STATEMENT OF ENVIRONMENTAL EFFECTS - Supplement

Second storey addition

Of:
24 Keldie Street,
Forestville, 2087
NSW

This Statement of Environmental Effects Supplement accompanies the Revised Development Application (DA) V5.1.2 for the provision of a new floor addition to the existing house with a reduced side boundary envelope impact.

B3 Side Boundary Envelope – Does not comply

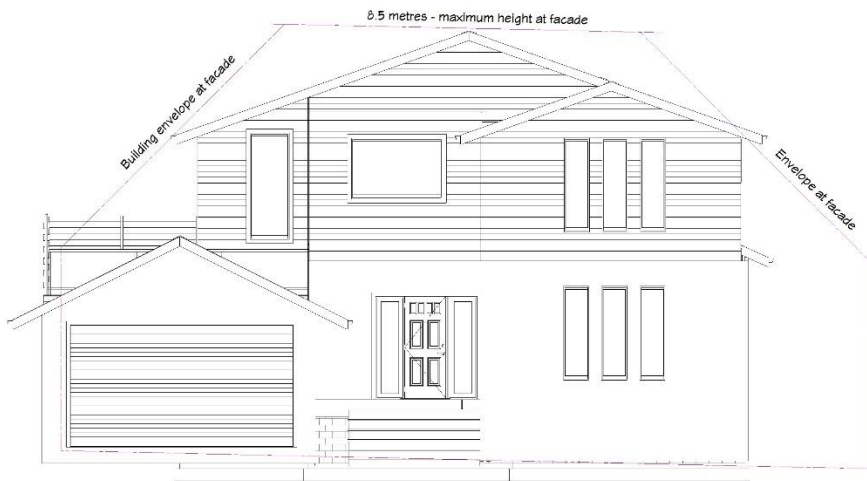
The development is well within the building envelope on the northern side that is determined by projecting planes at 45 degrees from a height above ground level (existing) at the side boundaries of 4 metres.

- The staircase space noncompliance has been reduced from 1.2metres to 1.0 metre
- The living/ rumpus room is now only noncompliant by a few cm
- Bed2, Bed3 and the ensuite are now compliant due to elevation of the land, the moving of the exterior wall and the increase in roof pitch.

Hypothetical building envelope at facade to demonstrate building bulk vs the envelope

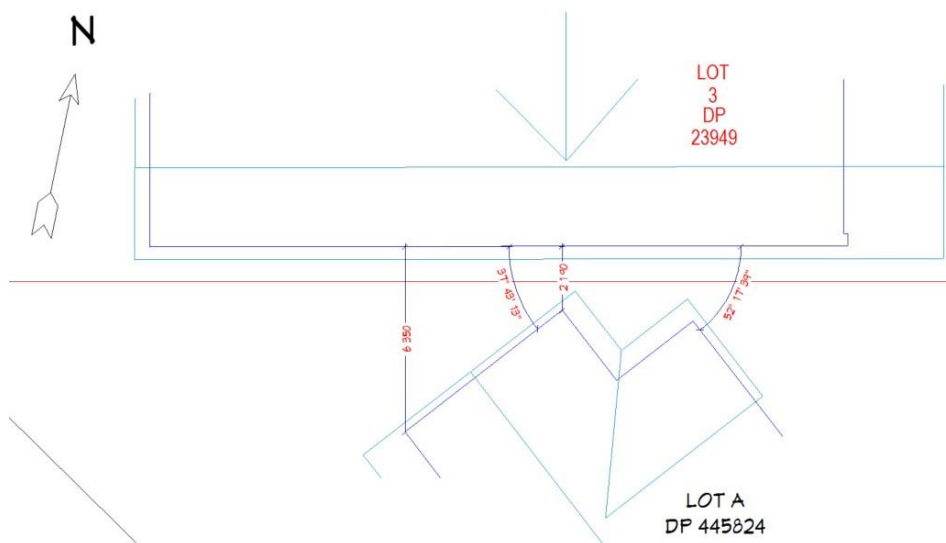
- *To ensure that development does not become visually dominant by virtue of its height and bulk.*
 - The proposed upper storey has not become dominant by the virtue of its height and bulk as per the objective of this control.
The upper storey is non-compliant, in a reduced form, on the south side while on the north side the upper storey is substantially inside the building envelope.
 - The non-compliance no longer has bulk due to the articulated first storey wall and hence the bulk of the upper storey is in line with the control's objective.
